ALASKAN WAY VIADUCT

EVALUATION OF GRAY'S RETROFIT PROPOSAL

Prepared for the
Washington State Department of Transportation

By
T.Y. Lin International

Figure 19a Floorbeam curvature ductility demand, retrofitted structure, rare earthquake, upper level

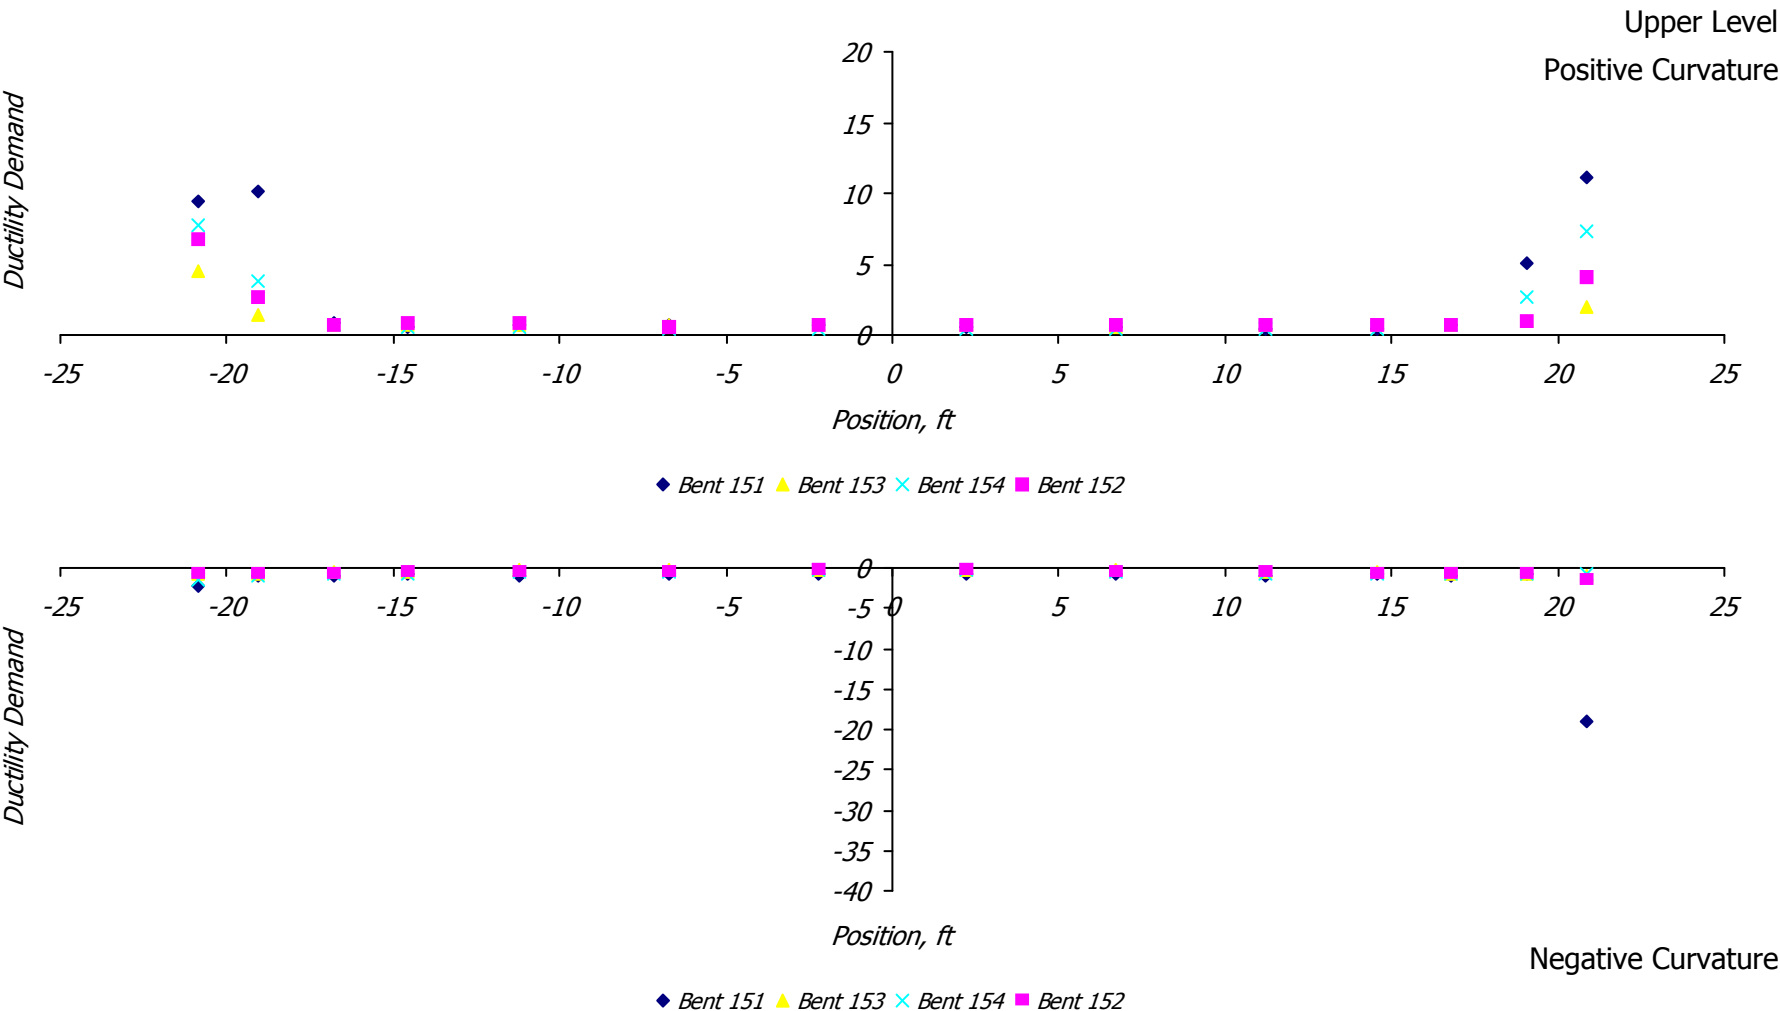
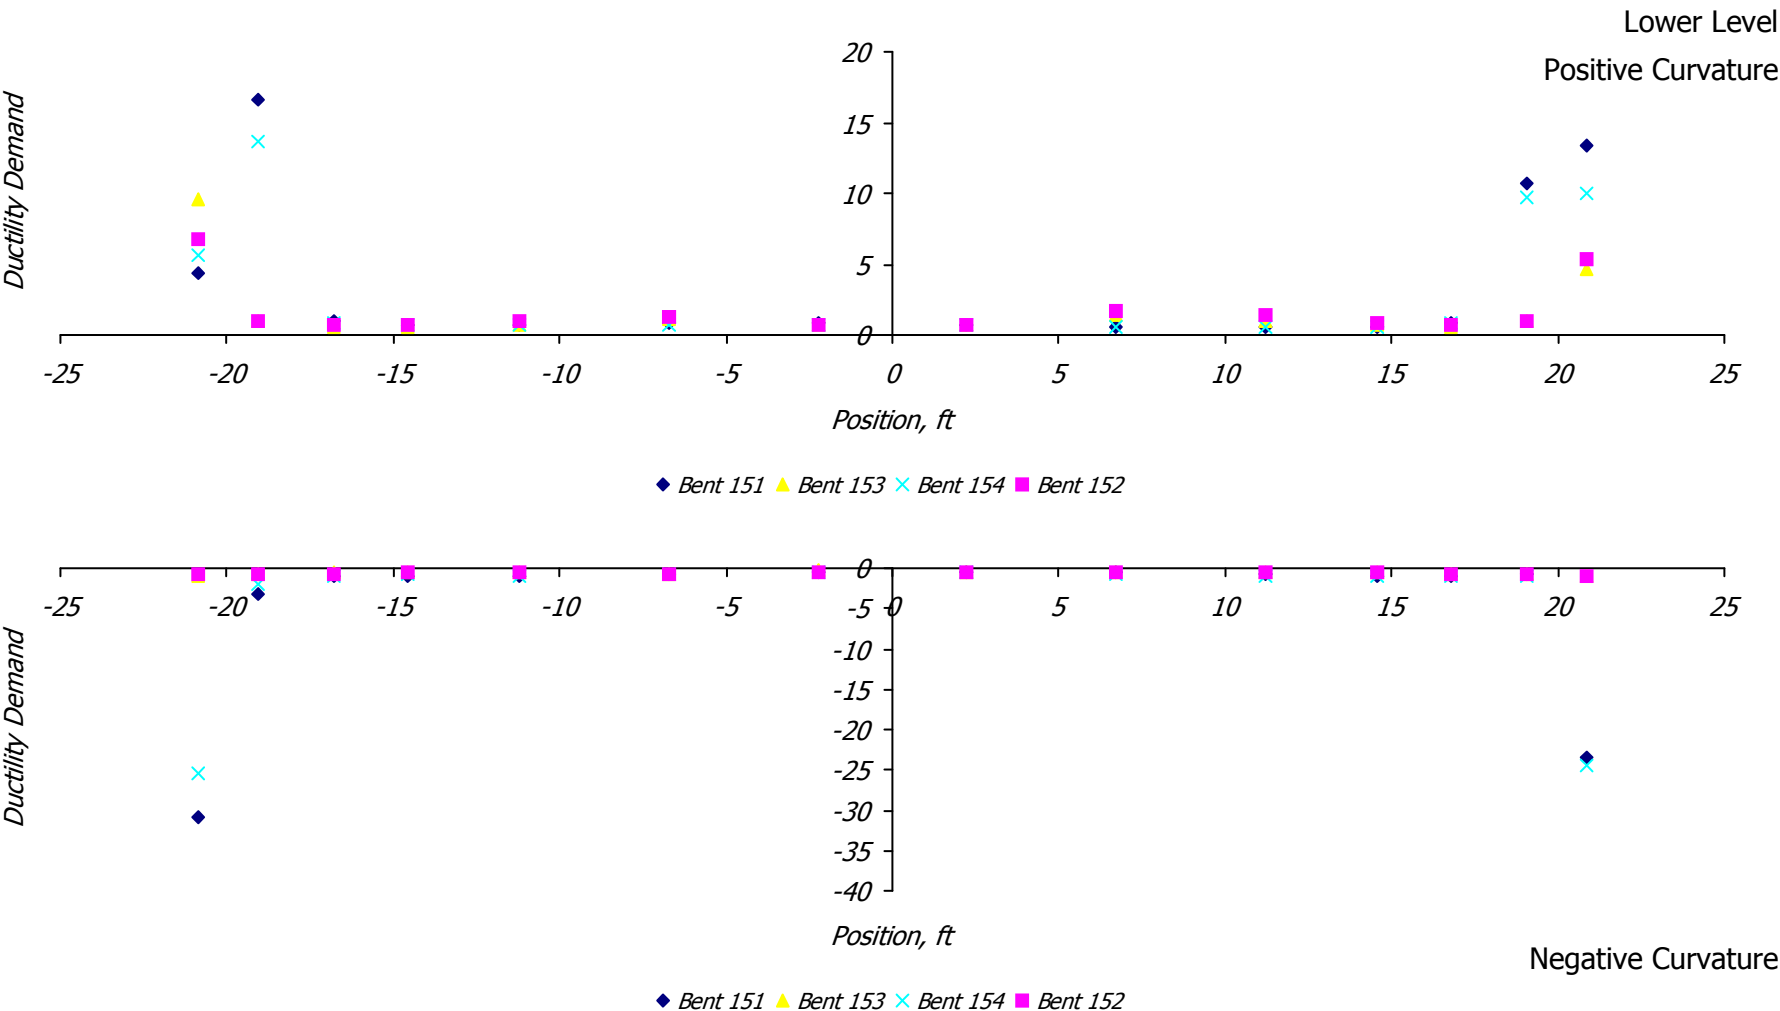
For the rare earthquake, the curvature ductility demands on the floorbeams are summarized in Figure 19. There are separate plots for the upper and lower level floorbeams, and positive (∪) and negative (∩) demands are plotted separately. The plots show that plastic hinges form at the faces of the columns. The largest demands are for positive bending. The floorbeams are reinforced asymmetrically to resist primarily vertical loads and have little bottom reinforcement at the column faces. Evidently, the seismic moments exceed the dead load moments at the faces of the columns so that the total moments are positive. (In the units design by the WSDOT, the primary load path for dead loads is through the edge girders).

Figure 20a

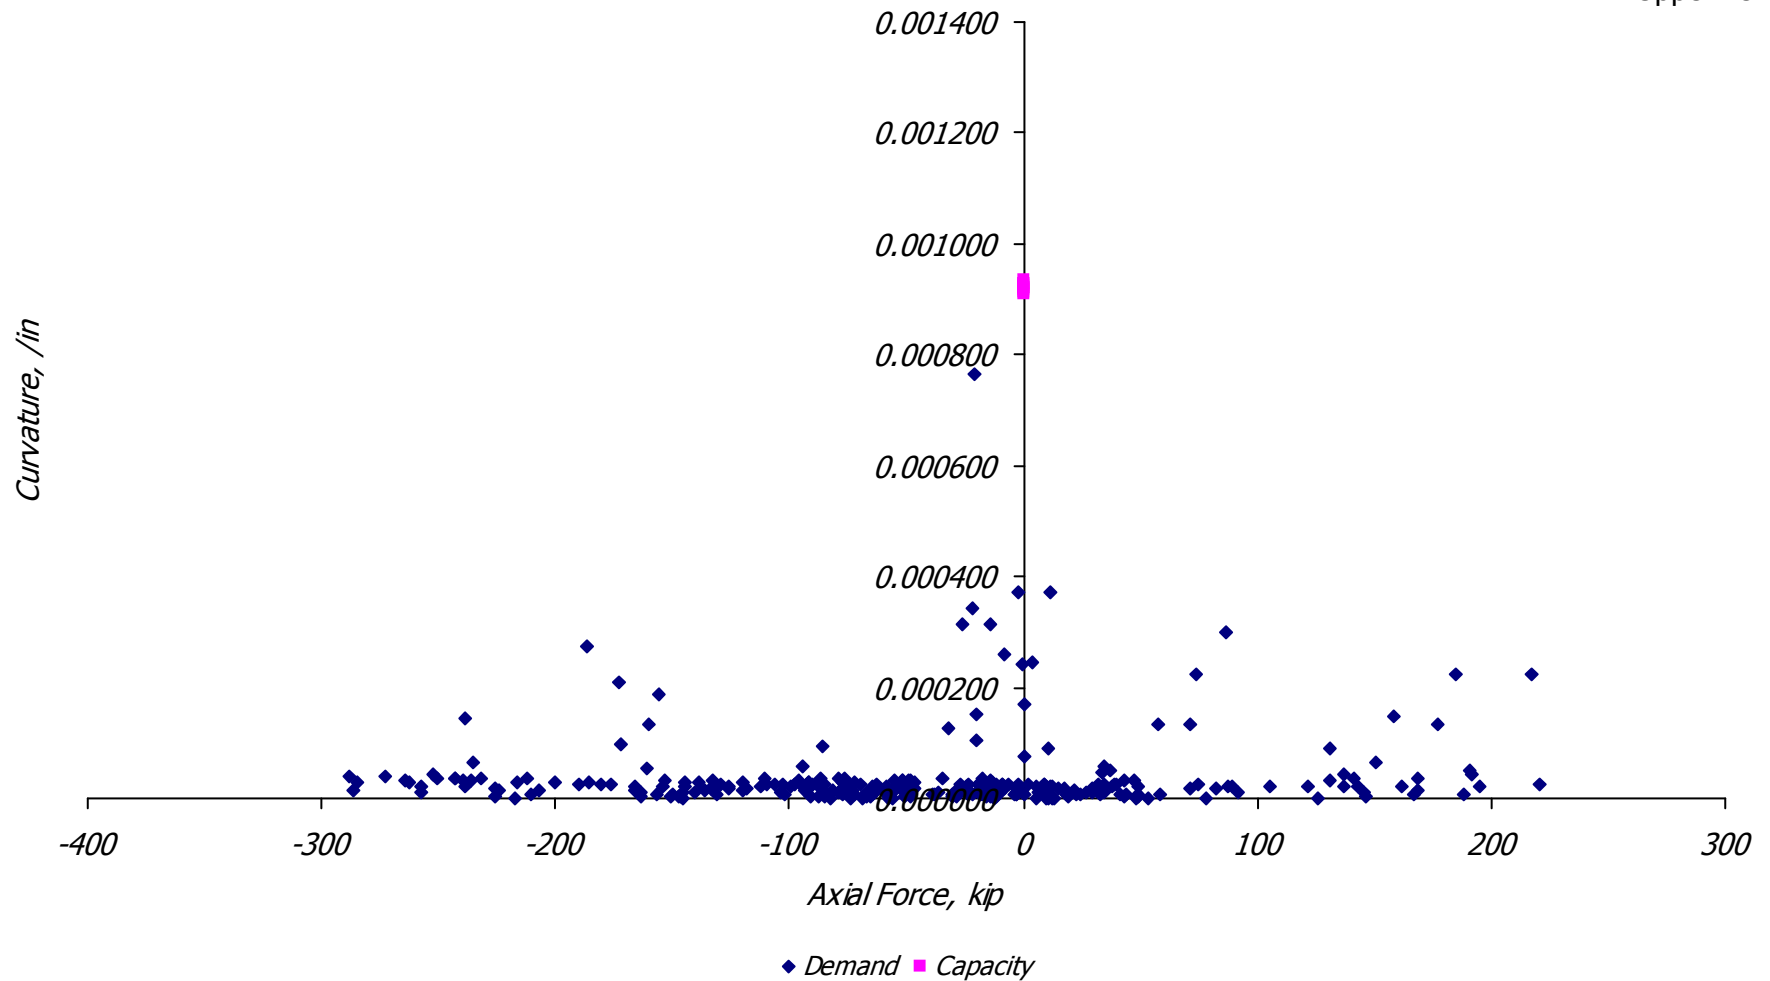
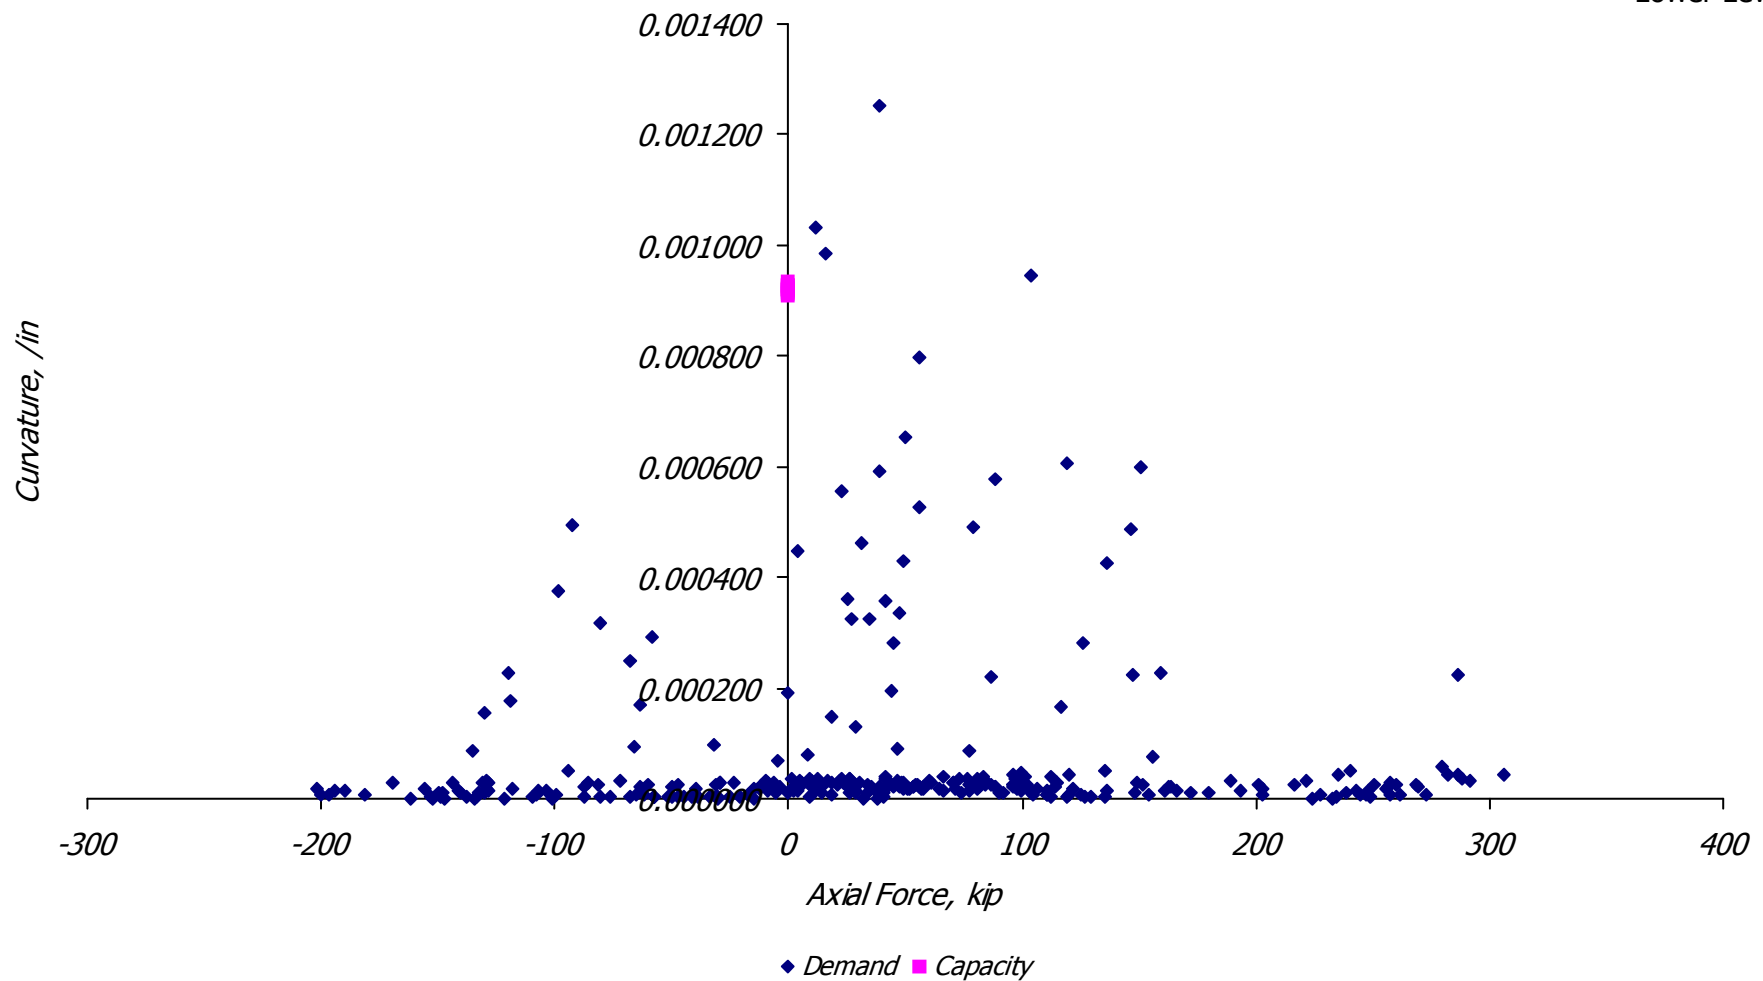
Plots of simultaneous curvature and axial force demands on the floorbeams are shown in Figure 20; there are separate plots for the upper and lower level floorbeams. The capacity curves are represented by clusters of points along the curvature axes (for axial forces of zero). This is because the capacities of the various floorbeams sections are nearly the same, and because the capacity was only calculated for an axial force of zero (because the axial forces in the floorbeams are modest).

Figure 20b indicates that the lower level floorbeams will fail in flexure—in negative bending near one of the columns. This same failure was predicted by the pushover analysis described in Section 4.2.1.1. A demand/capacity ratio of 1.20 was obtained for the middle bents from that analysis. A similar ratio may be inferred from Figure 20b.

Figure 21b

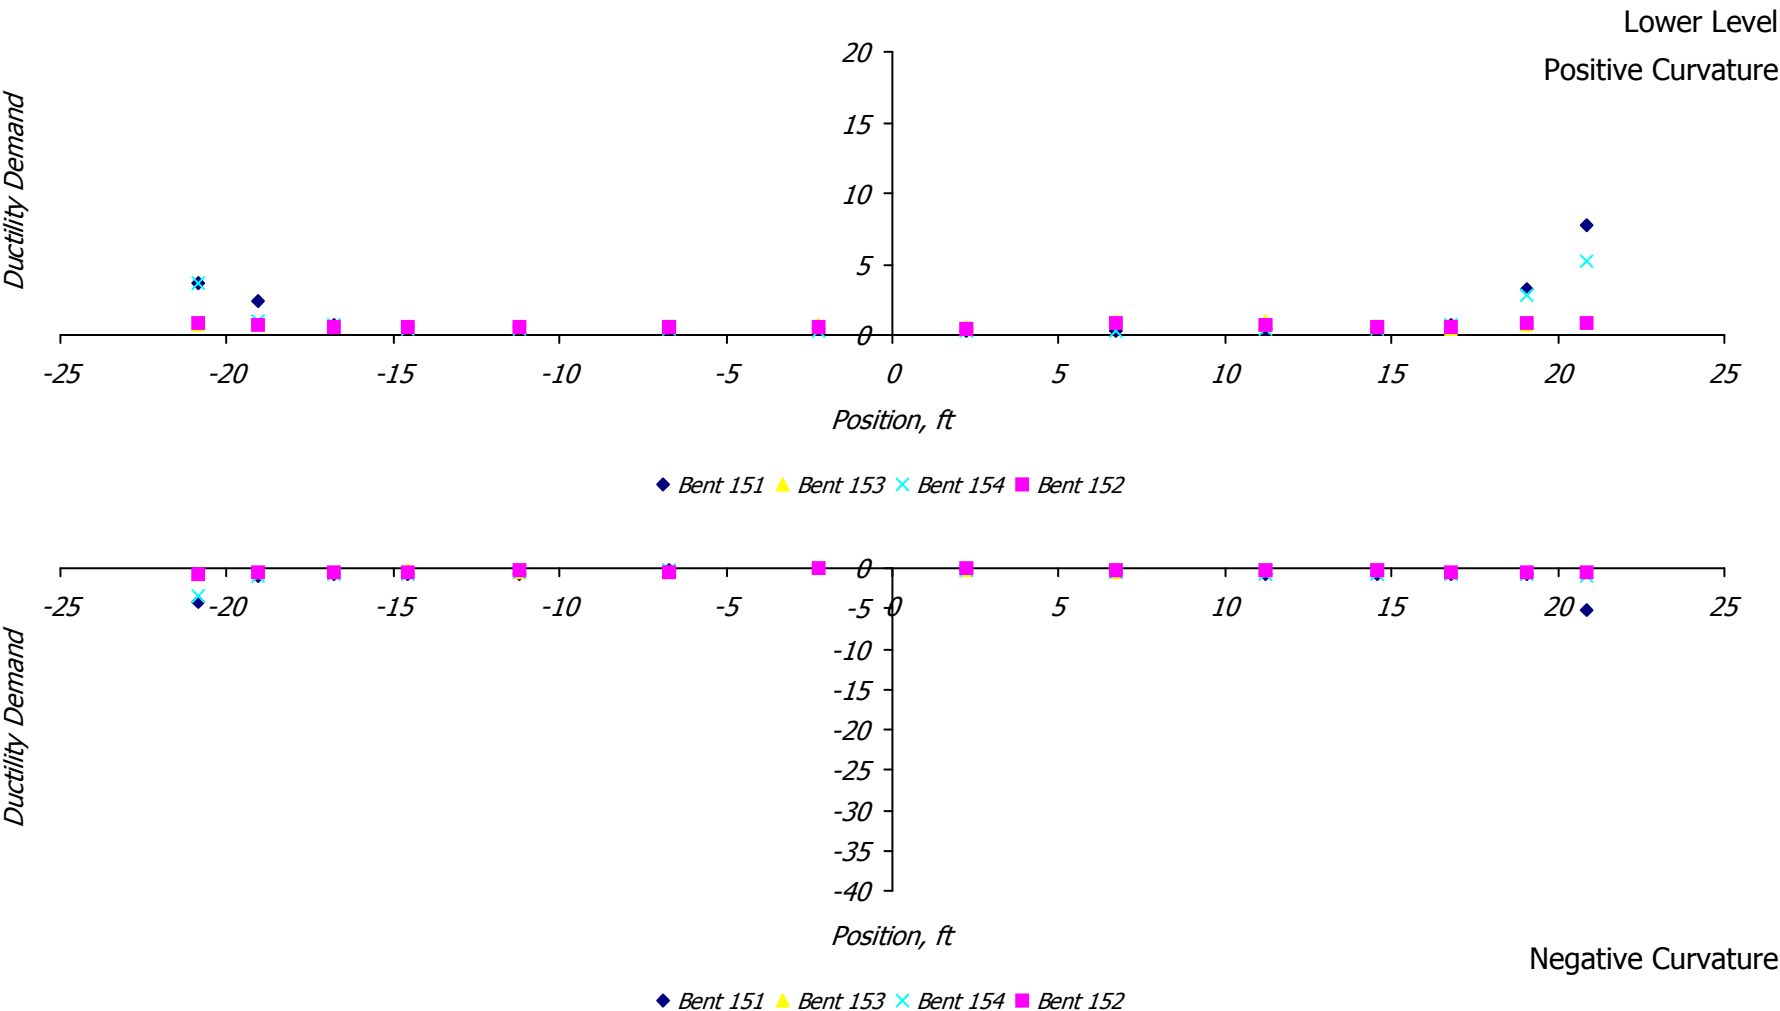
For the design earthquake, the curvature ductility demands on the floorbeams are summarized in Figure 21. The largest demands occur on the lower level floorbeams, and are up to 7.8 in positive bending and 5.2 in negative bending. These values are large enough to cause significant cracking and yielding of reinforcement, but within the limits for repairable damage provided that there is not major degradation in development of reinforcing details.
